ADDENDUM 1

ADDENDUM DATE: November 05, 2024

PROJECT: Onslow County Senior Services Center Renovation
4024 Richlands Highway
Jacksonville, NC 28540

4
A2-01
ELEVATION - NORTH
1/8" = 1'-0"

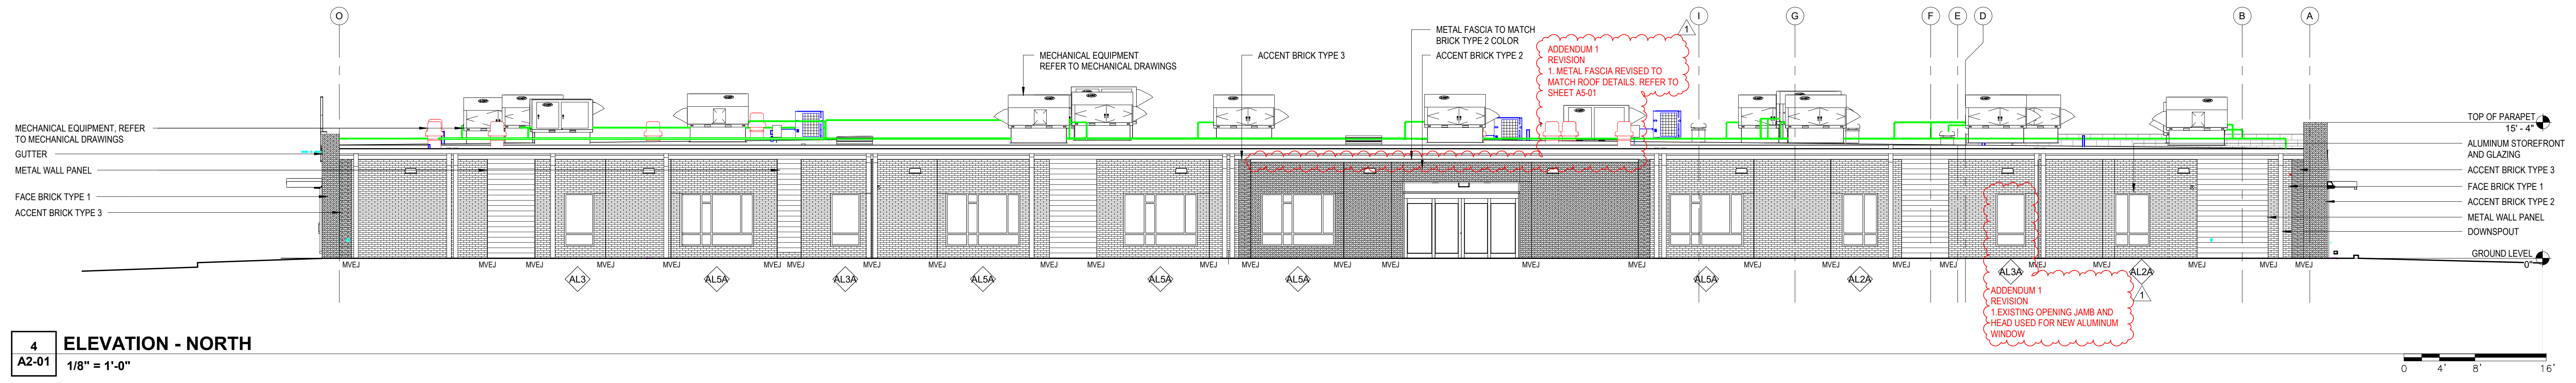
- 1/A2-01, 2/A2-01 and 4/A2-01 - Revision to metal fascia. Refer to sheet A5-01.
 - 4/A2-01 - Use existing opening head and jamb in lieu of a new opening in the existing wall for new aluminum window. Refer to demo elevations, A0-07.

7 ACTIVITY ROOM 116A CABINET SECTION
A4-04 1" = 1'-0"

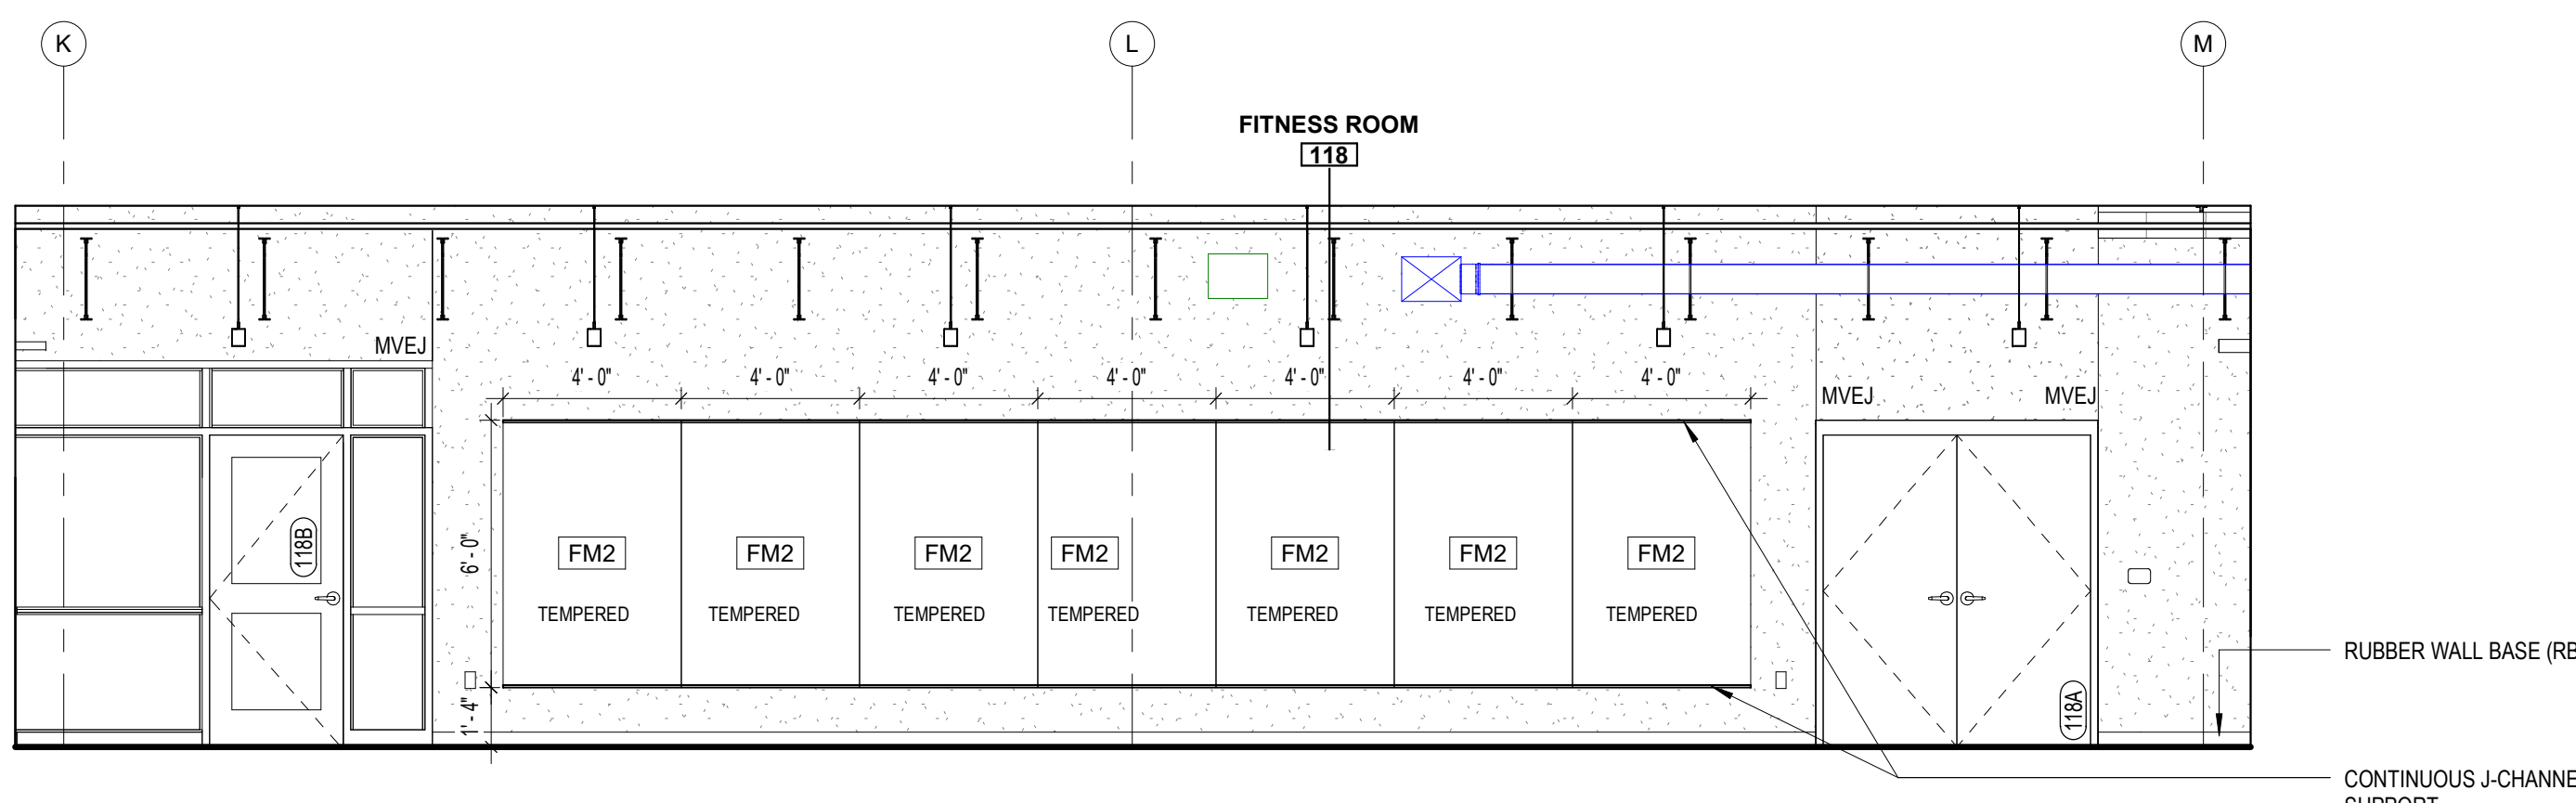
ADDENDUM 1
REVISION:
1. WALL LINER SS1 HAS BEEN REMOVED.
2. RUBBER BASE ADDED NEAR KNEE SPACE.
3. COUNTERTOP SS1 DEPTH HAS INCREASED TO 3'-0".

10 ROOF DETAIL
A5-01 1 1/2" = 1'-0"

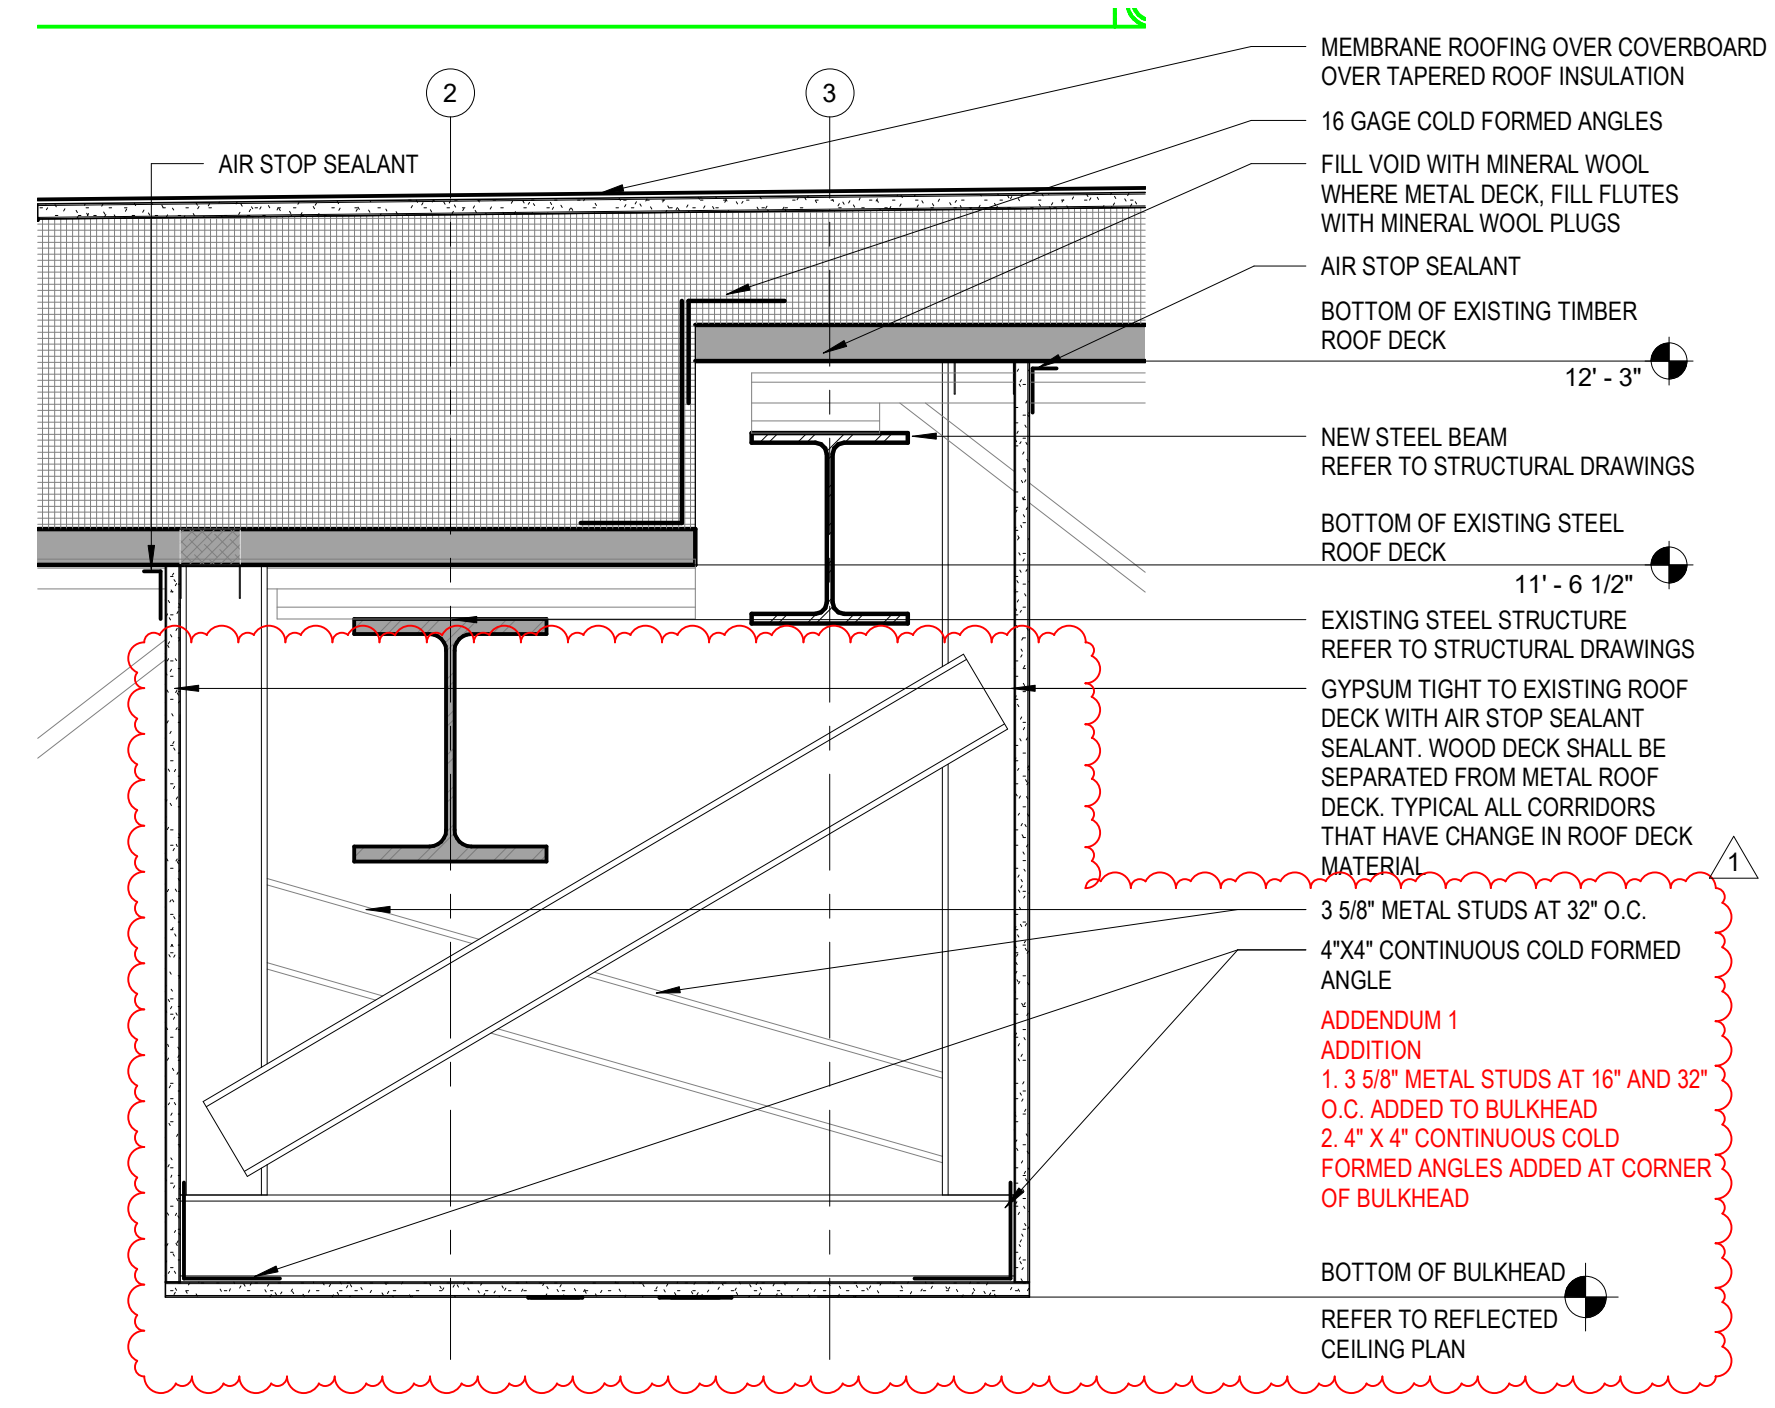
- 4/A5-01 and 10/A5-01 - Addition of 4"x4" continuous cold formed angle at corners of bulkhead.
- Item 23 Sheet A5-02: REPLACE the sheet in its entirety with the attached sheet A5-02.
Note the following revisions:

1 HEAVY TIMBER PARALLEL TO JOIST ROOF EDGE DETAIL
A5-01 1 1/2" = 1'-0"

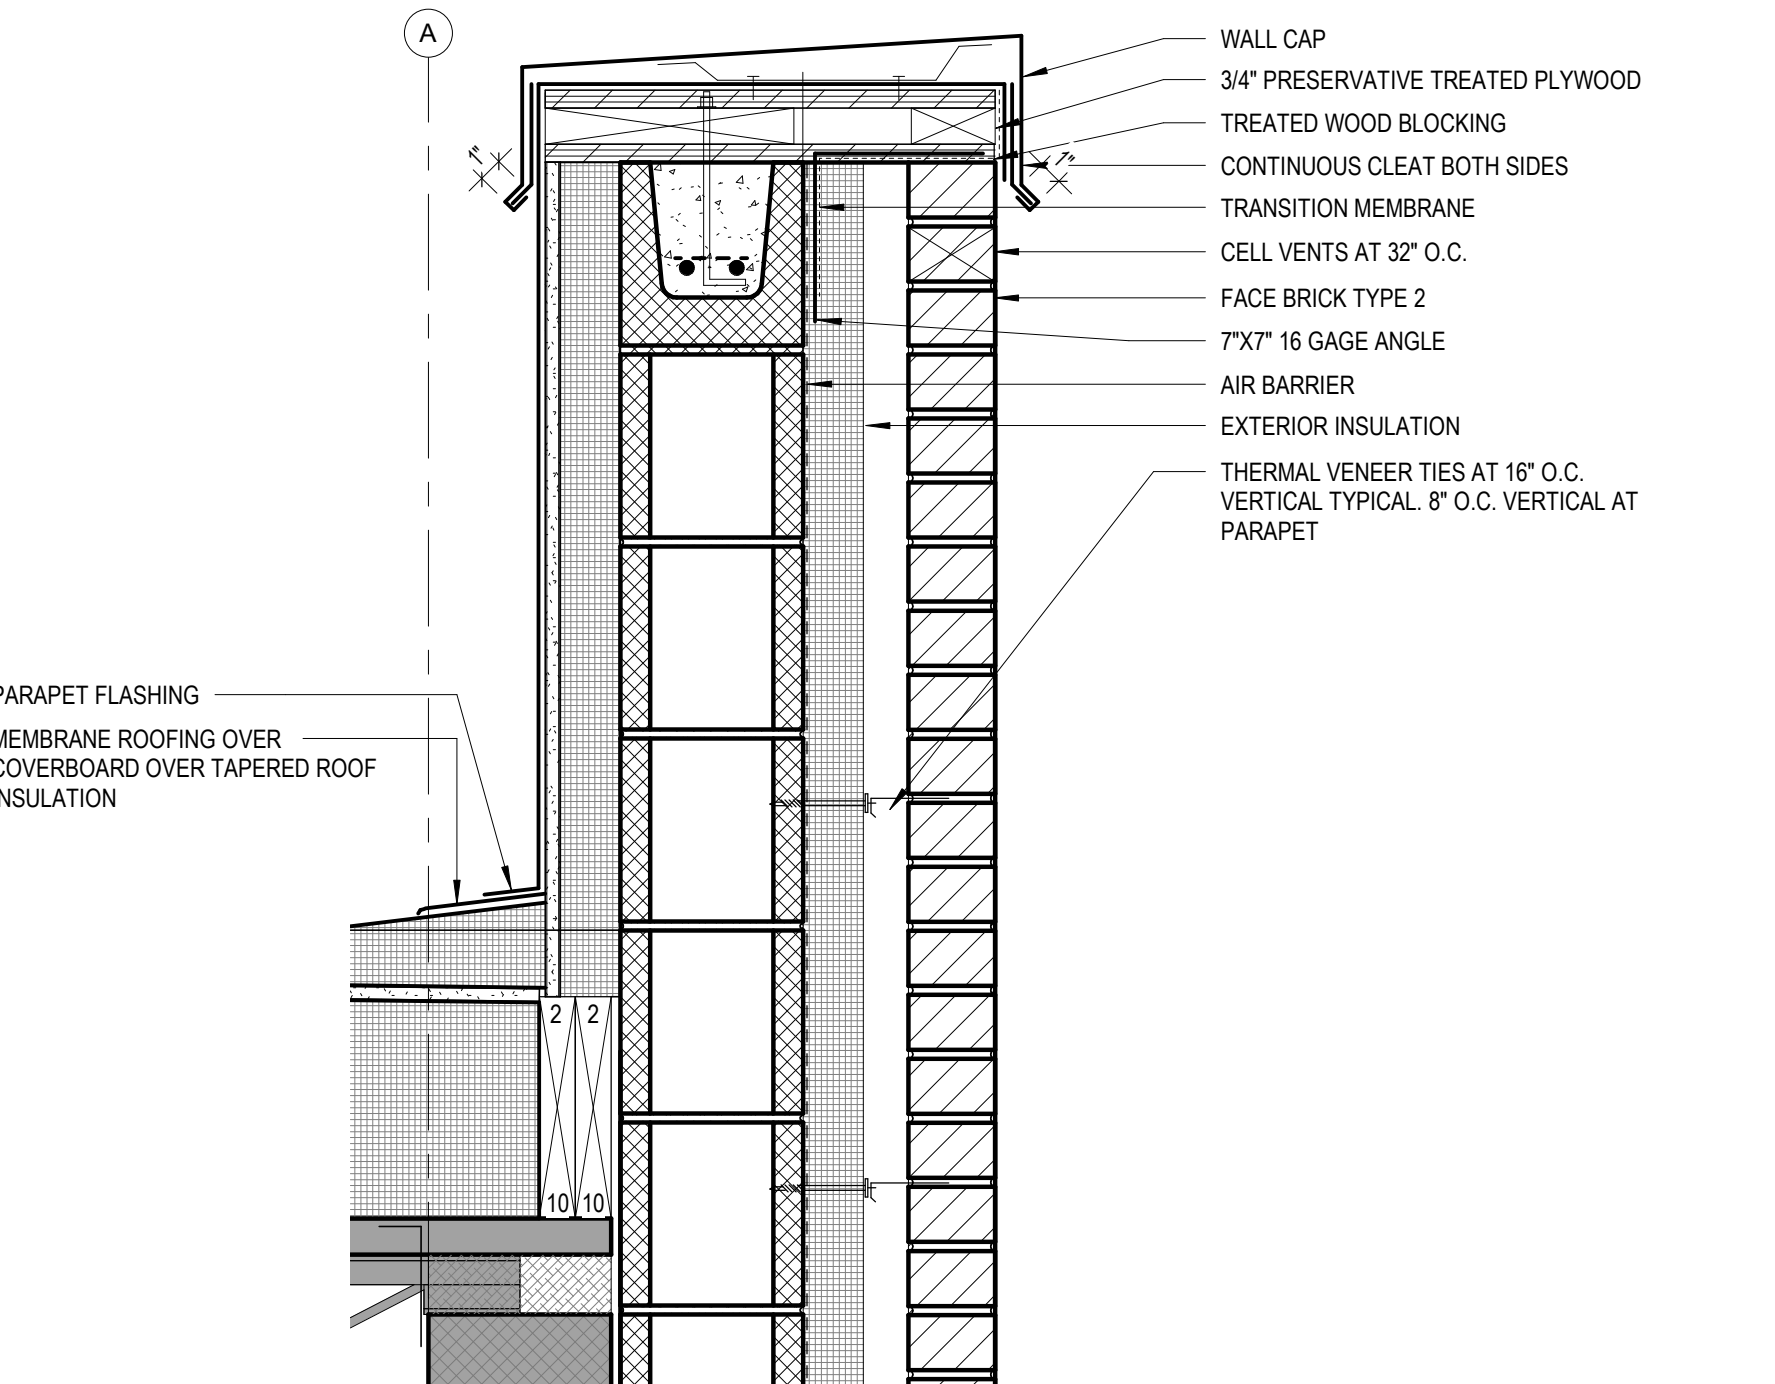
- Item 22 Sheet A5-01: REPLACE the sheet in its entirety with the attached sheet A5-01.
Note the following revisions:
- 1/A5-01, 2/A5-01, 5/A5-01, 6/A5-01, 7/A5-01, 8/A5-01, 9/A5-01, 12/A5-01 and 13/A5-01 - Revision to metal fascia.

15 ACTIVITY ROOM - OPERABLE PARTITION DETAIL
1 1/2" = 1'-0"

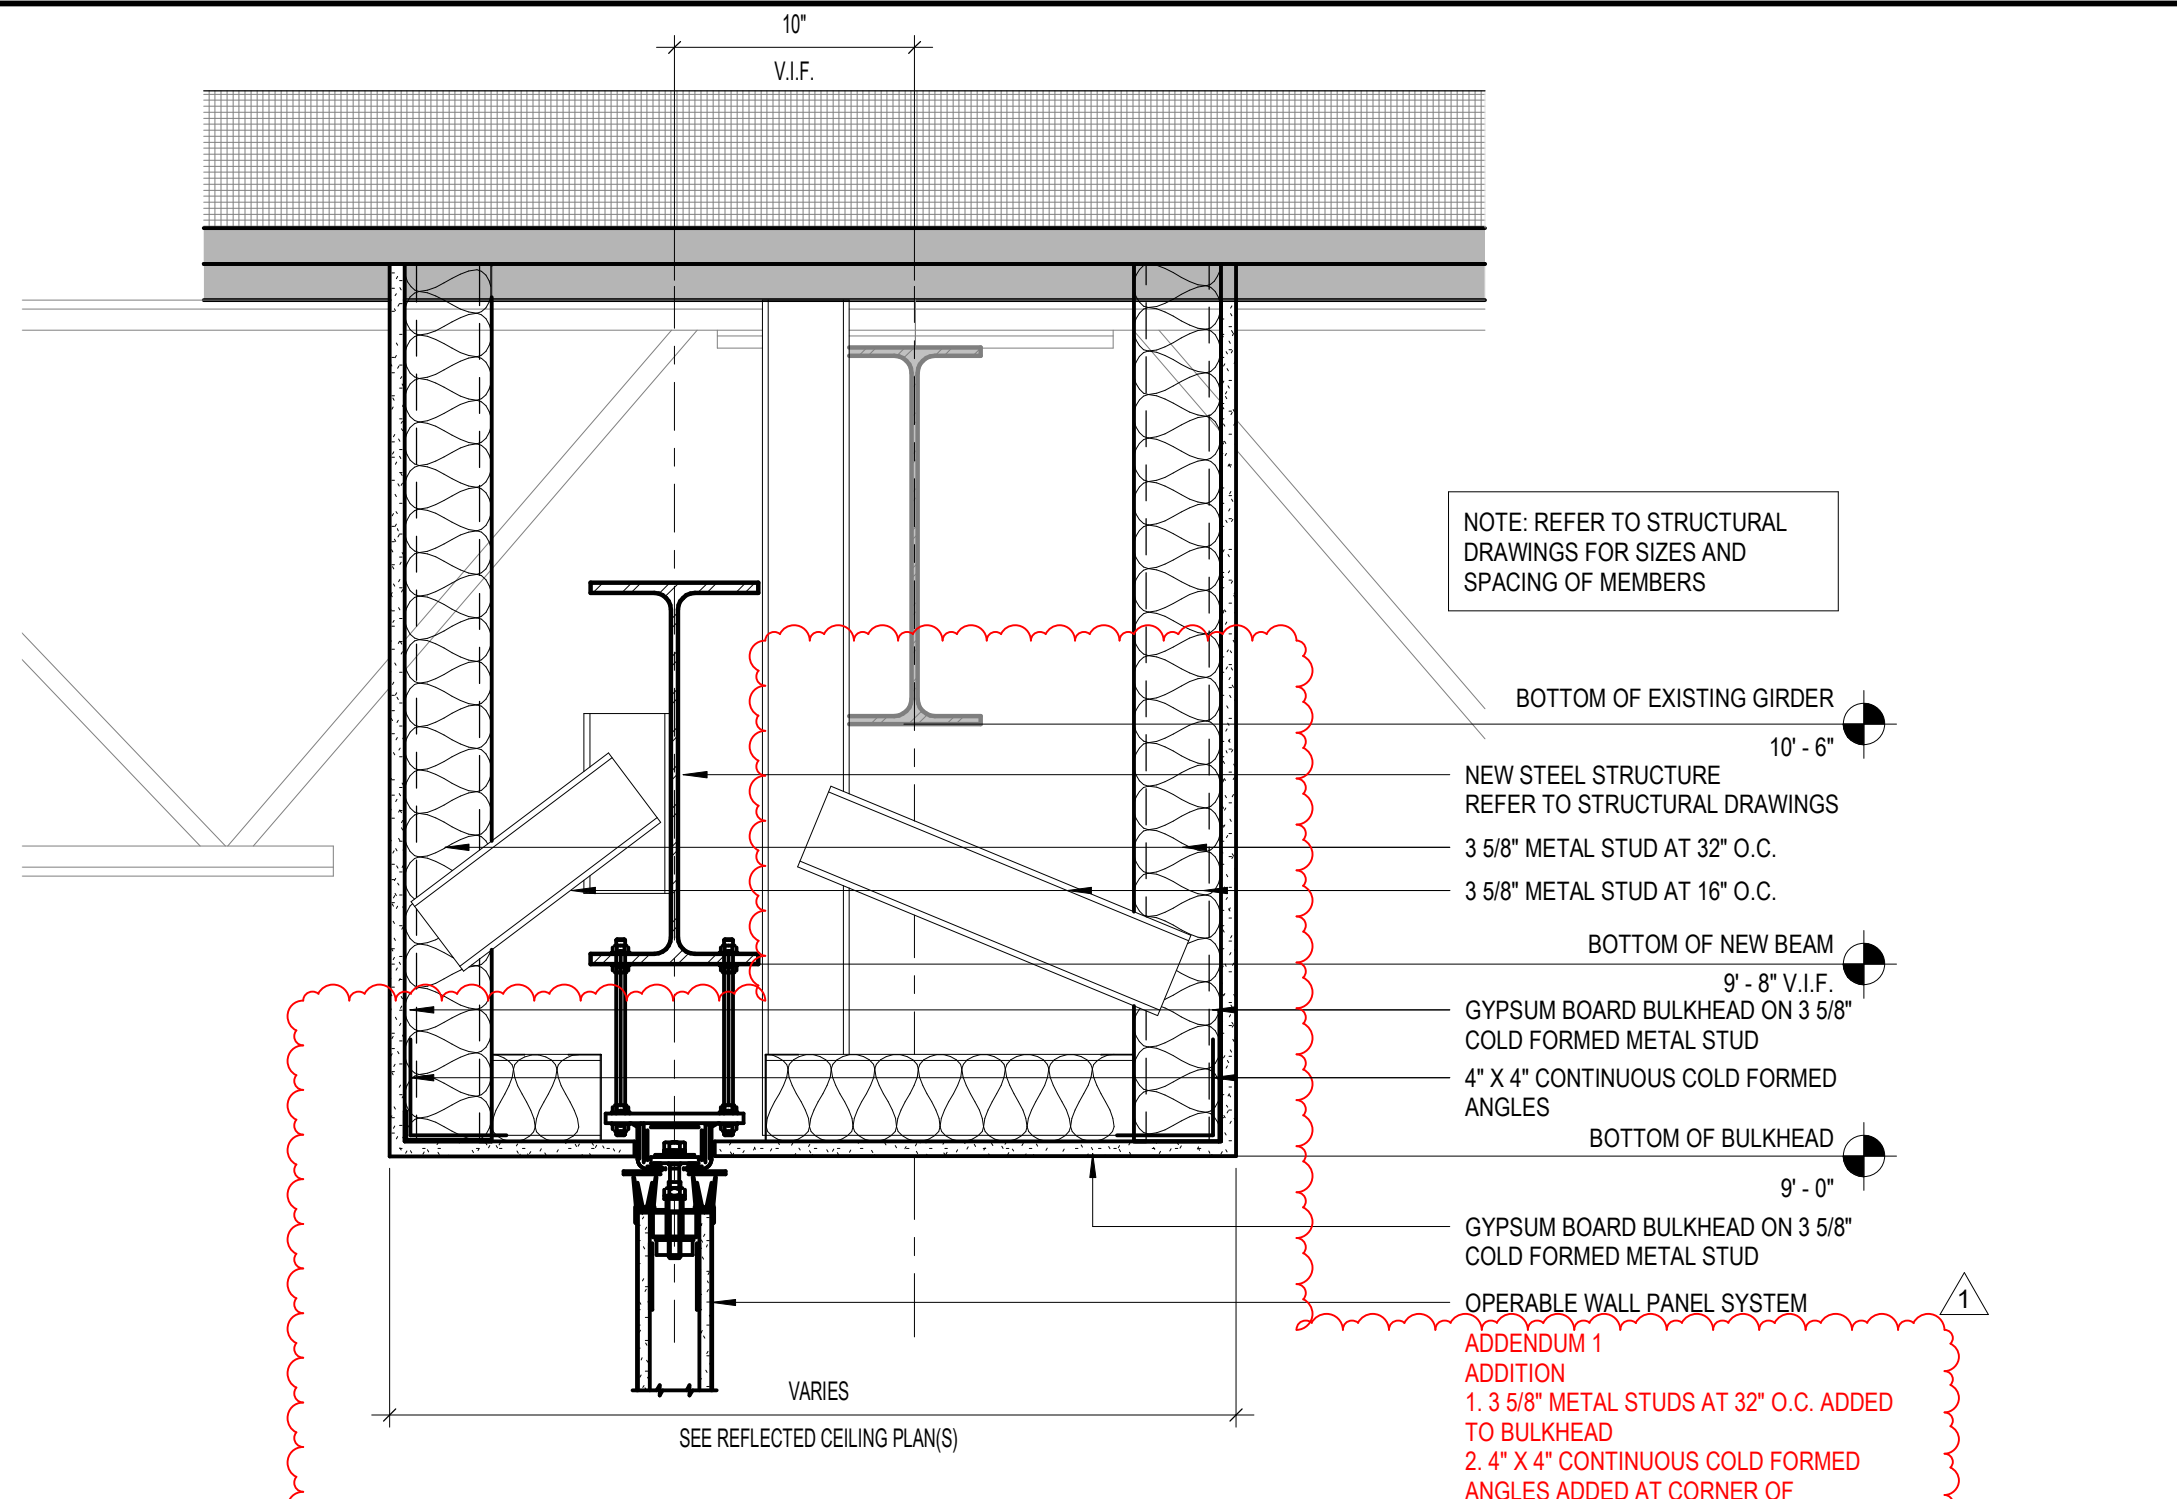
- 7/A5-03 - Addition of 3 5/8" metal studs at 32" O.C. added to bulkhead.
 - 7/A5-03 and 15/A5-03 - Addition of 4"x4" continuous cold formed angle at corners of bulkhead.
